**Addendum No. 1
BL162-23
Harris Elementary School Fire Flow Improvements**

The following addition/changes modify the Bid No. BL162-23 "Harris Elementary School Fire Flow Improvements" Contract Documents, dated November, 2023, as first advertised on November 08, 2023.

Harris Elementary School Fire Flow Improvements

PROJ. NO. 36555-17

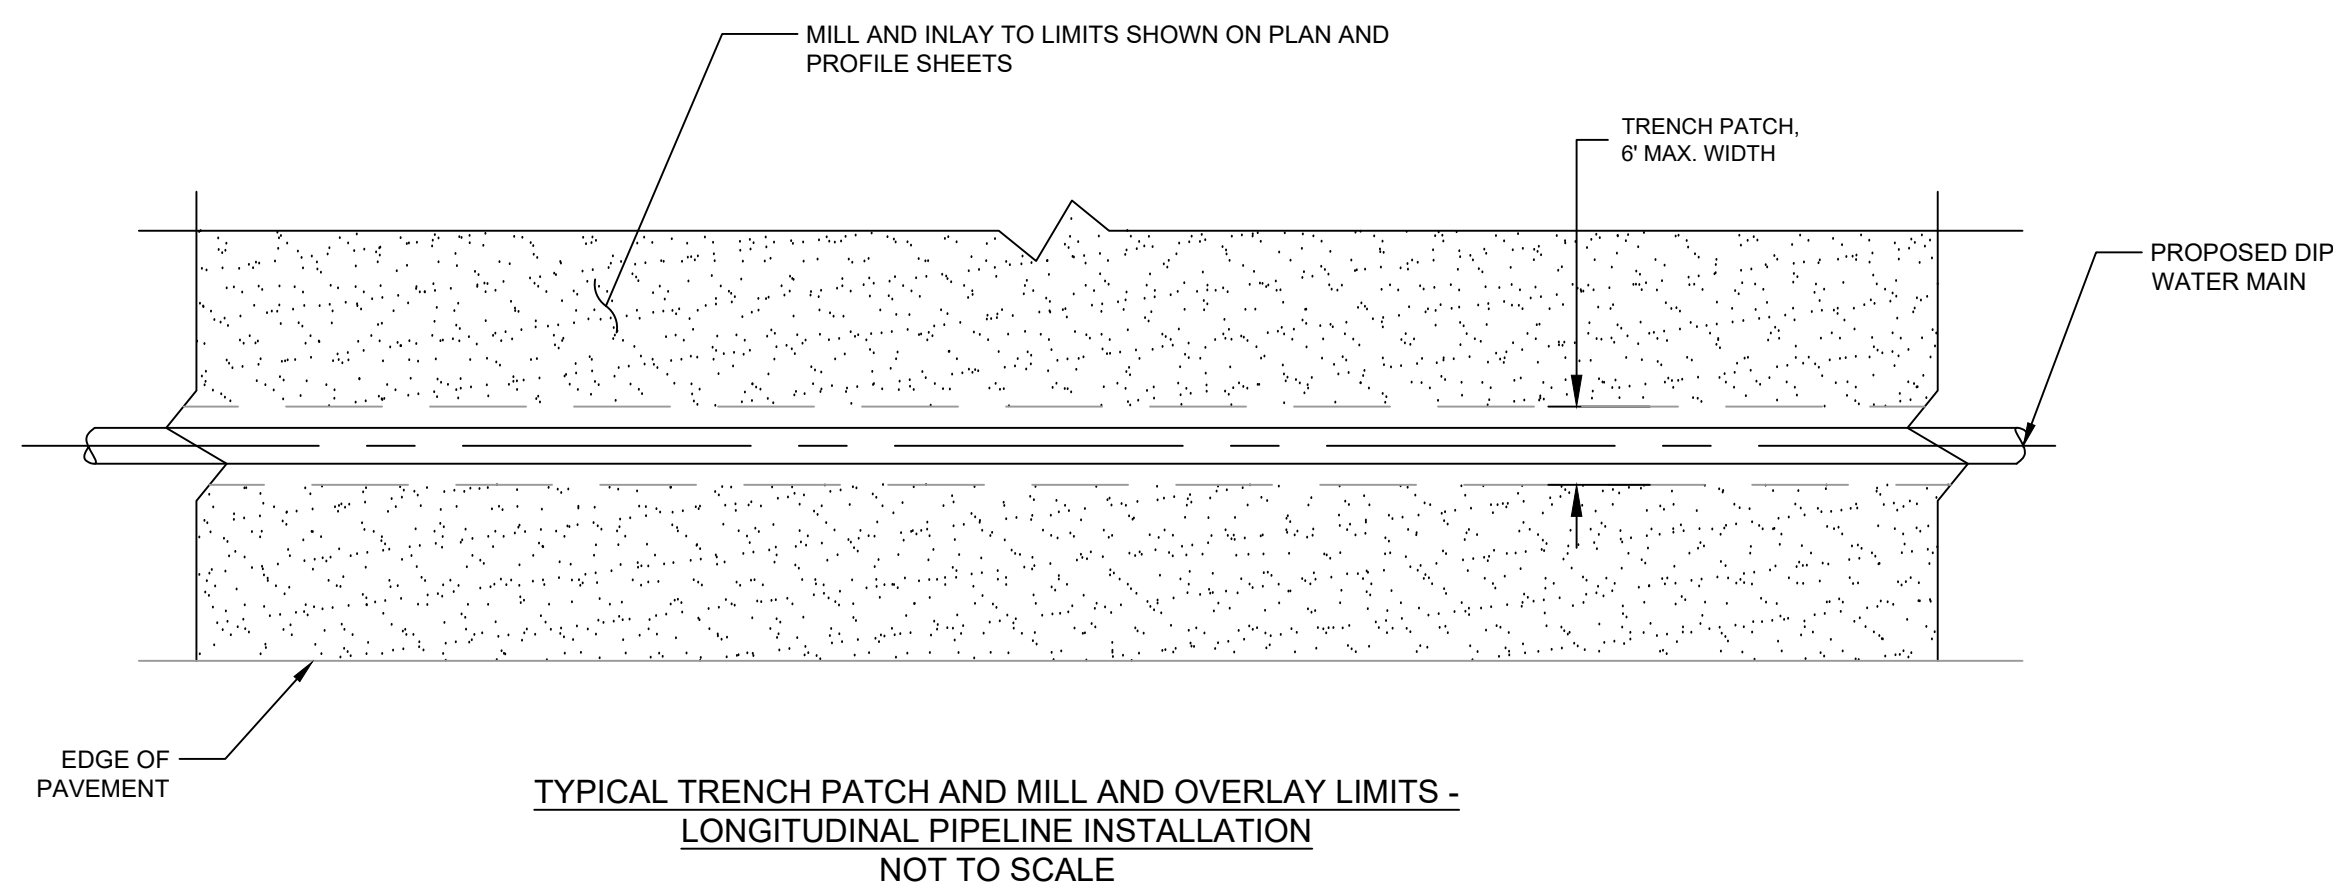
- Q1. Plan page CD.04 Note 1. Will this Gab as described be paid under line item #12 for its usage to stabilize the road during construction?
A1. Yes.
- Q2. There is no borrow line item - will it be paid under Engineered Directive Earth excavation removal and replacement if soil is deemed not meeting standards?
A2. Removal is paid for with Item ODW5 Earth Excavation. Replacement material will be Additional Pipe Bedding paid for under Item ODW4 Additional Pipe Bedding.

- Q7. Please confirm compaction is 95% or 100% under roadway.
A7. See detail titled "Typical DIP Water Main Paved Area Trench" on Drawing CD.04.
- Q8. Will hydrants be paid complete as the bid tab does not note Type A Hydrant? Several hydrants are not on the mainline so I wanted to confirm 6" DIP will be paid by the foot off the hydrants.
A8. Correct, fire hydrant assemblies are inclusive of all hydrants regardless of Type A or not. Specification Section 01 22 15.11, Standard Pay Item Description 36 stipulates pipe is included in the cost of the assembly.

- Q15. For rock removal payment is the lesser of the payable trench width the actual trench width excavated in the field as described in 01 22 15.11, 5.a or, a maximum of 4.45' as shown in "Typical DIP Water Main Paved Area Trench" Detail found on Sheet CD.04?
A15. Maximum rock removal pay limits shall be as described in Specification Section 01 22 15.11, 5.a.

1. Drawing CD.04, Detailed Titled "Typical DIP Water Main Paved Area Trench"
REVISE the second to last word of Note 1 to read "driving".
2. Drawing CD.04, Detailed Titled "Typical DIP Water Main Paved Area Trench"
ADD the following Note 4: "Where use of steel plates over the trench is necessary to provide a temporary driving surface during the course of construction, the contractor shall provide steel plating and associated temporary asphalt to anchor steel plating in place at no additional cost to the Owner. Such work shall be considered incidental to the project and shall not be measured or paid for separately."

- NOTES:
- CONTRACTOR SHALL PLACE GAB TO EX GRADE UPON INITIALLY BACKFILLING TRENCH. CONTRACTOR SHALL MAINTAIN GAB SURFACE IN ROADWAY FREE OF RUTS, MAINTAINING A SMOOTH DRIVING SURFACE.
 - DURING INITIAL TRENCH PATCHING, PLACE BASE COURSE MATERIAL TO FINISHED GRADE. WITHIN SEVEN CALENDAR DAYS OF BACKFILLING TRENCH AND PLACING INITIAL TEMPORARY GAB SURFACE.
 - FINISHED SURFACE COURSE TO BE PLACED VIA MILL AND INLAY AFTER WATER MAIN INSTALLATION AND TIE-IN'S AND SERVICE SWITCH OVERS ARE COMPLETE.

1. WHERE USE OF STEEL PLATES OVER THE TRENCH IS NECESSARY TO PROVIDE A TEMPORARY DRIVING SURFACE DURING THE COURSE OF CONSTRUCTION, THE CONTRACTOR SHALL PROVIDE STEEL PLATING AND ASSOCIATED TEMPORARY ASPHALT TO ANCHOR STEEL PLATING IN PLACE AT NO ADDITIONAL COST TO THE OWNER. SUCH WORK SHALL BE CONSIDERED INCIDENTAL TO THE PROJECT AND SHALL NOT BE MEASURED OR PAID FOR SEPARATELY.
